TO: Mercedes-Benz Dealer Principals, General Managers,	FROM: Gregory Gunther, Senior Manager, Vehicle
Sales Managers, Service Managers, Parts Managers	Compliance and Analysis, Engineering Services
RE: Service Campaign Launch Notification	DATE 1 10 0001
Replace B-Pillar Identification Label	DATE: January 19, 2024
MY20-21 GLA and GLB (247 platform)

Campaign No. 2023100012, January 2024

SUBJECT: Model GLA and GLB (247 platform)

Replace B-pillar Identification Plate

Figure 1

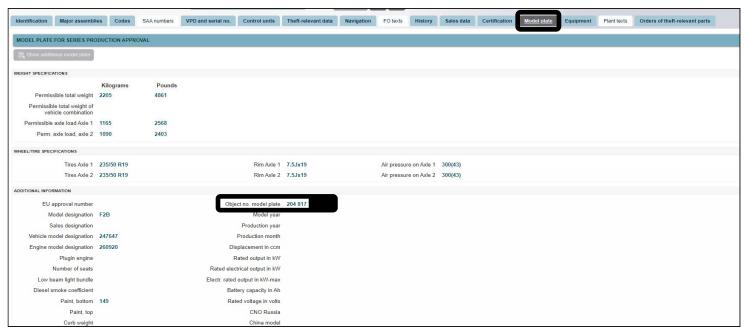
Mercedes-Benz AG ("MBAG"), the manufacturer of Mercedes-Benz vehicles, has determined that on certain MY 2020-2021 GLA and GLB (247 platform) vehicles, the identification plate on the B-pillar does not correspond to current specifications. An authorized Mercedes-Benz dealer will replace the identification plate on the B-pillar.

- 1. Replace identification plate on B-pillar.
 - i Determine correct part number of identification plate in XENTRY Portal via VeDoc (**Figure 1**) and place order.
 - $oxed{1}$ Heat identification plate with heat gun. Remove adhesive residue of old identification plate and clean bonding area.
 - Li Attach new identification plate over old bonding position (Figure 2).
